ACCESS REPORT
DEVELOPMENT APPLICATION

35 WILFRED BARRETT DRIVE
ENTRANCE NORTH

MULTI-UNIT RESIDENTIAL DEVELOPMENT

The purpose of this report is to provide an accessibility review of a Development Application for a multi-unit "affordable housing" development on a site at 35 Wilfred Barrett Drive, North Entrance.

DA03

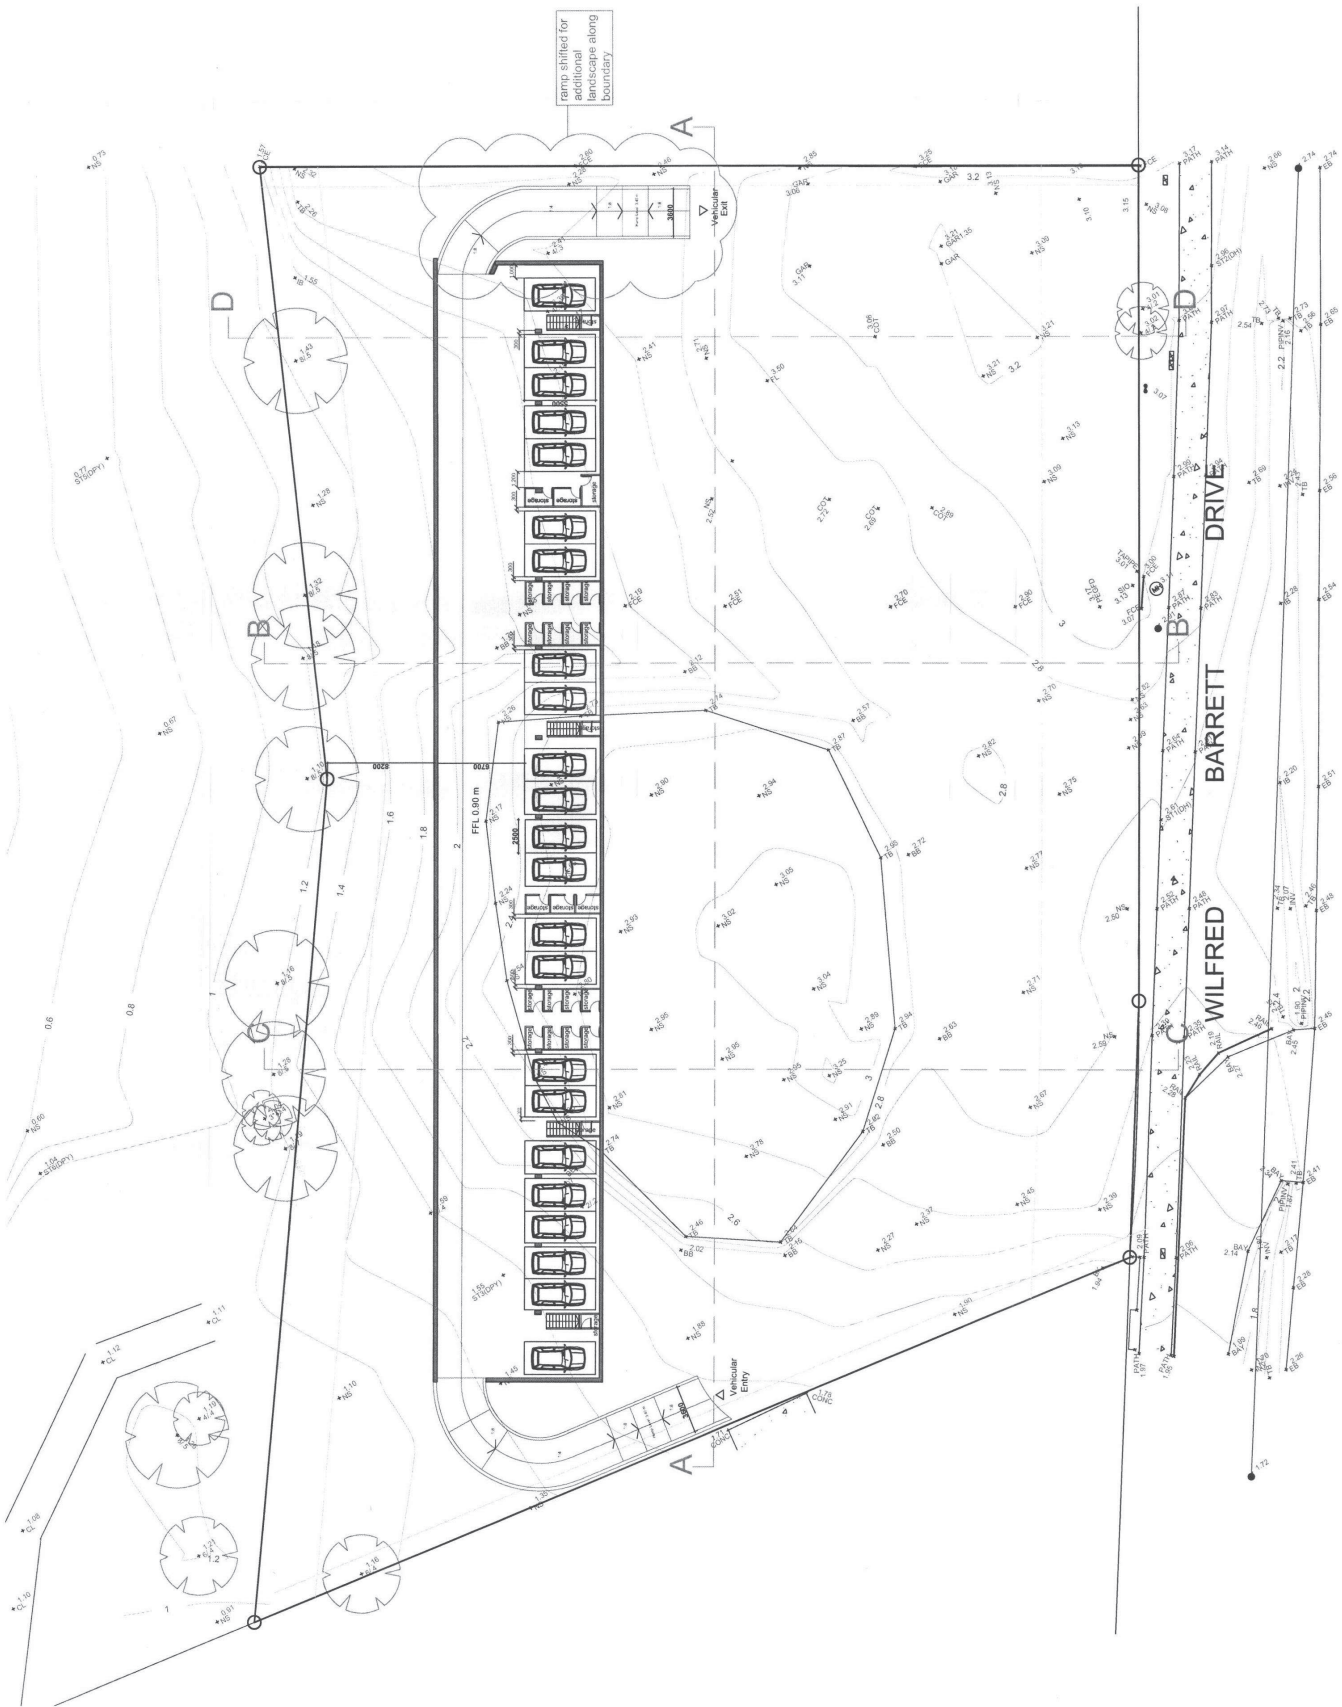
Clause	Accessibility Assessment – Common Domain	Compliance	
BCA Table D3.1	<p>Site Access Paths - The plans show an entrance that provides on-grade access with 1:20 gradient walkways, 1:14 gradient ramp and 1:10 step ramp access from the public domain footpath to the front entry door of all twenty-one (21) ground floor units to satisfy Table D3.1 of the BCA.</p>	YES	
	<p>Details of ramp handrails and tactile indicators shall be confirmed at construction certificate stage in accordance with ASI428.1 and ASI428.4.1.</p>		
	<p>The Common Landscaped areas between the buildings propose on-grade transition access from the paved ramp landings which enables satisfactory access to this soft landscaped area and communal facility.</p>		YES
BCA D3.3(a)(ii) D3.8	<p>Stairways In accordance with part D3.3(a)(ii) of the BCA the stairways will be detailed at construction certificate stage with handrails on both sides to the requirements of ASI428.1, step nosings, closed risers and tactile ground surface indicators.</p>	YES

Clause	Adaptability Assessment	Compliance
AS4299 Clause 3.7	<p>Resident Car Parking</p> <p>The carpark provides five (5) X 4800mm width resident parking spaces to satisfy AS4299, including extra transfer space for people with mobility restrictions.</p> <p>The car spaces will be graded at a 1:40 maximum slope and crossfall in accordance with AS2890.</p> <p>The outdoor parking provides unrestricted height clearance over the designated accessible parking space in accordance with AS4299.</p>	YES
AS4299 Clauses 4.3.1, 4.3.2 and 4.3.3	<p>Accessible entries – The front entrances to the adaptable units provide at least 1550mm X 1550mm externally and internally with 530mm minimum latch side clearance, which complies with the spatial requirements of AS4299.</p>	YES
AS4299 CIs 4.3.7	<p>Interior of ground floor: general – With regard to the internal corridor and doorway approach to a <u>main bedroom</u>, adaptable bathroom and storage facilities the development complies with the doorway circulation space requirements of AS1428/4299.</p>	YES
